## North Hill Communities Heritage Guideline Development Permit and Applications Overview

This document provides an overview of received applications within the Heritage Guideline Areas that were subject to discretionary review or comment from Heritage Planning and Community Planning with regard to heritage considerations.

Permit: DP2024-00394

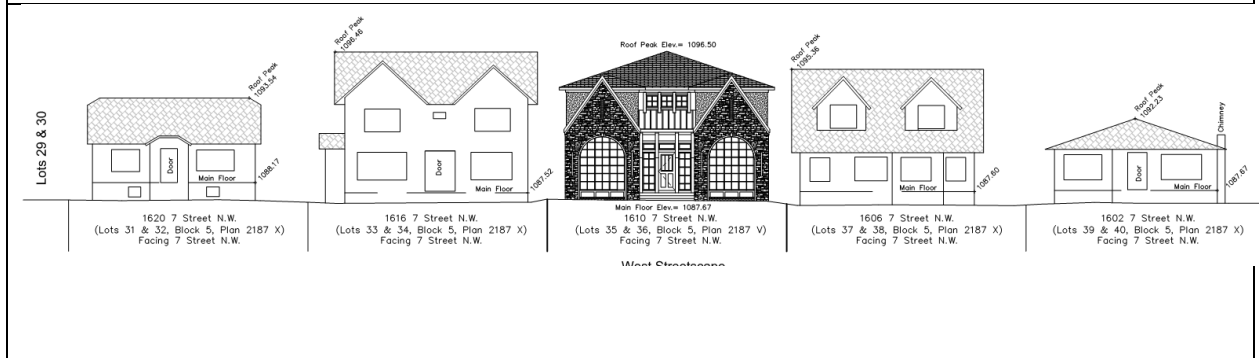
Notes: Associated with PE2023-01847. Expectations discussed during pre-application and reflected in the application. While modern, it still generally meets the design guideline expectations.
